Municipal Planning & Design Review Commission
Regular Meeting Agenda
Thursday, August 19, 2021, 5:30 PM
City Hall, Lakeland, Tennessee 38002

Subject: Action on approval of a Site Plan at 3469 Lake District Drive N – Lake District Outparcel 6.

We are pleased to submit the following responses to the staff comments regarding Lot 6 of the Lake District. The original staff comment is shown, followed by our response in green text.

SITE LIGHTING PLAN

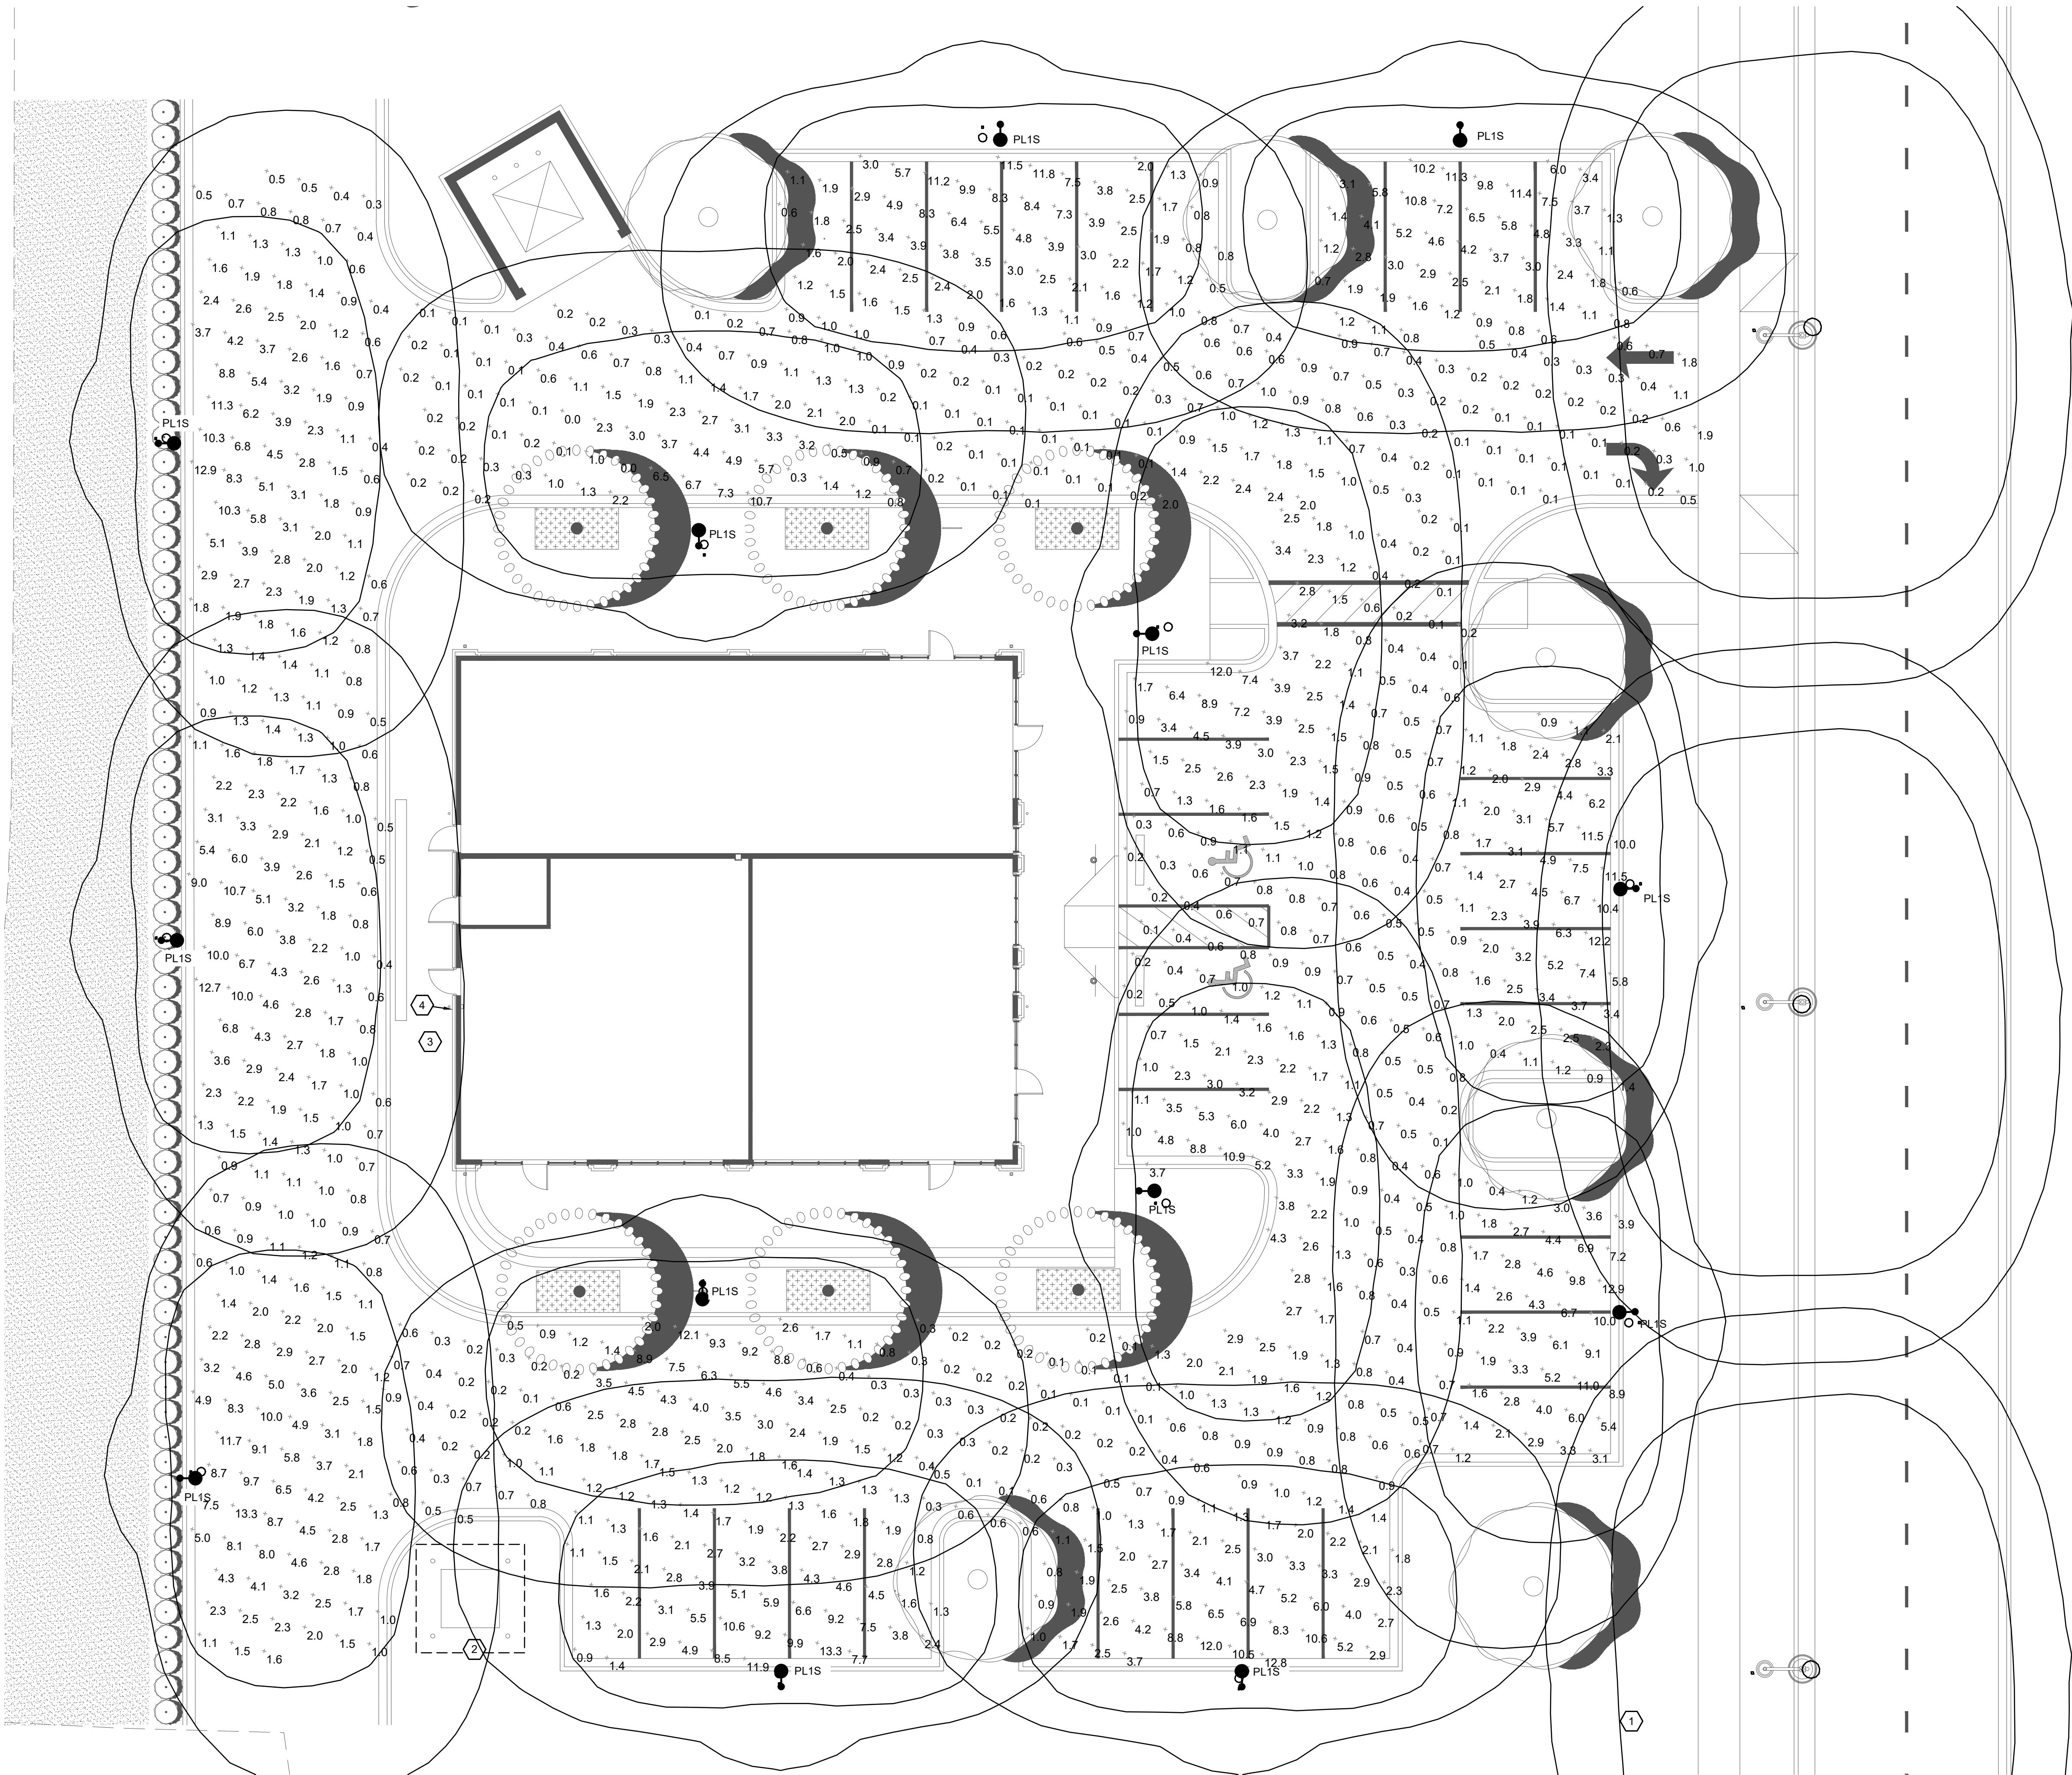
- The lighting plan does not show the property lines, nor does it show the footcandle measurements to the property line, but the circles indicating even light distributions extend past where the property lines should be. Staff is unable to determine by the exact amounts that are exceeded due to incomplete data.

5. It appears the photometric plan is not in compliance with this requirement. Please review and review as necessary. Measurements will need to be shown to the property line. From LDRs. For lighting levels, adjacent to commercial property, the lighting shall not exceed one (1) foot-candle of illumination at the property line, and shall not exceed one-half (1/2) foot-candle 10 feet over the property line.
